CMD Final Industry Stakeholder Comment Matrix

Name: Mark Thompson Organization: TransCanada Energy Ltd. (TCE)

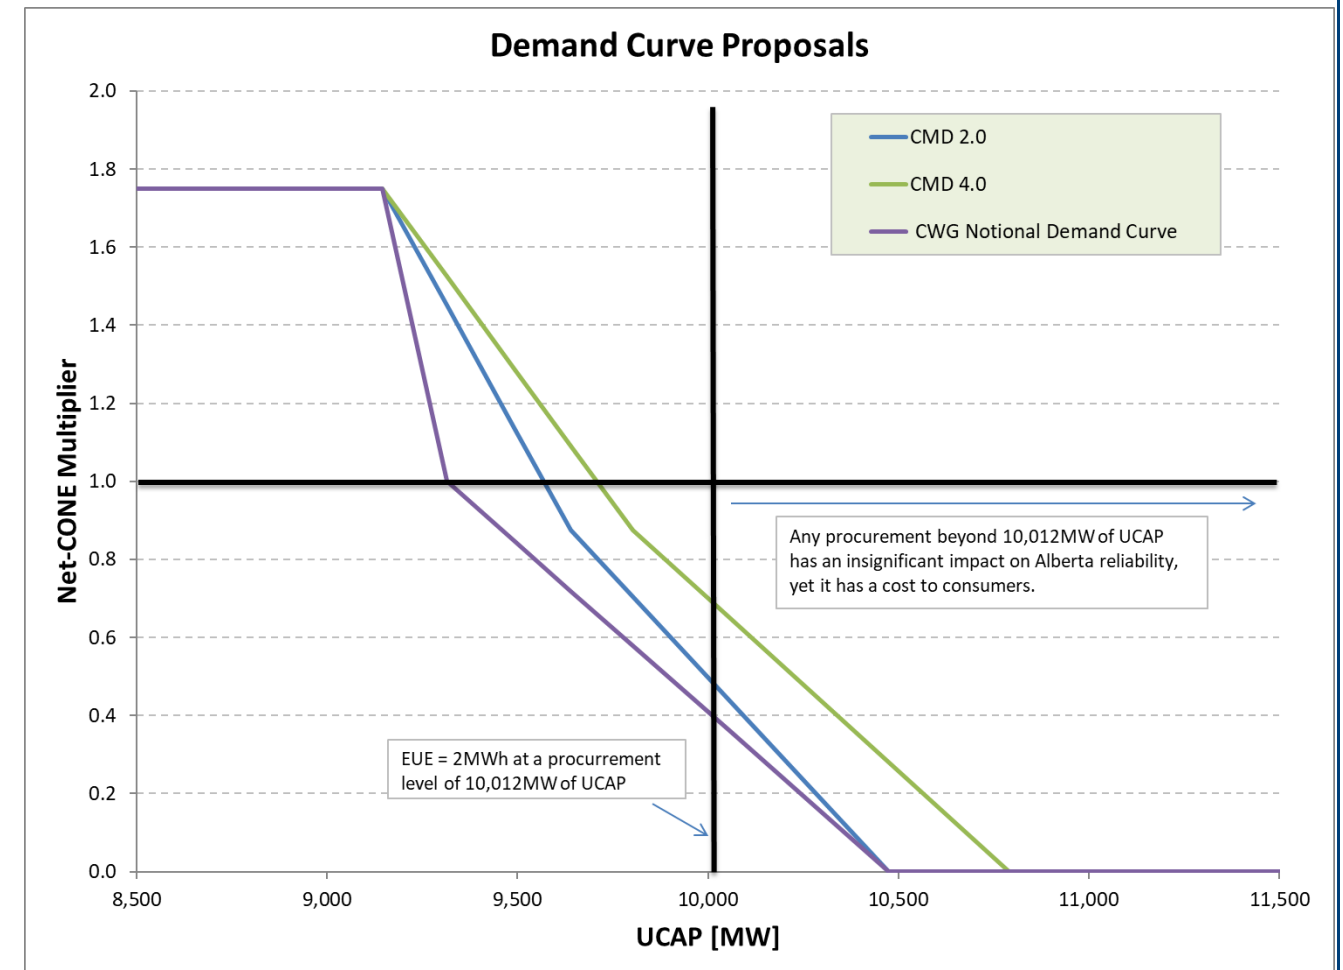
The use of the forward curve to set the energy market revenue for the entrant creates a number of issues that must be considered. The Alberta market is not liquid 3 years in the future, and small volumes can materially move price. This gives rise to the concern that the prices are not representative, as well as the concern that participants will be 'at risk' for forward transactions. For example, if a large participant enters into a forward transaction that moves the market in any material way, that participant will notionally be at risk for allegations that the transaction impacted its capacity market portfolio. This adds compliance risk for every transaction for a market that is already illiquid. The feedback loop between energy prices and the capacity market must be carefully considered and using the forward market to set net-CONE should not be the approach due to Alberta's small, illiquid market. Further, translation from forward prices to revenue for the reference technology is also not straightforward as plant utilization still needs to be forecasted.

Last, the energy revenue for the net-CONE calculation should be made assuming the market is in equilibrium. Otherwise, over-supply would drive future capacity prices up while under-supply would drive capacity prices down, which sends the wrong incentives. This can be achieved through a model, where forward prices would reflect market expectations for the delivery period, which may or may not reflect over- or under-supply.
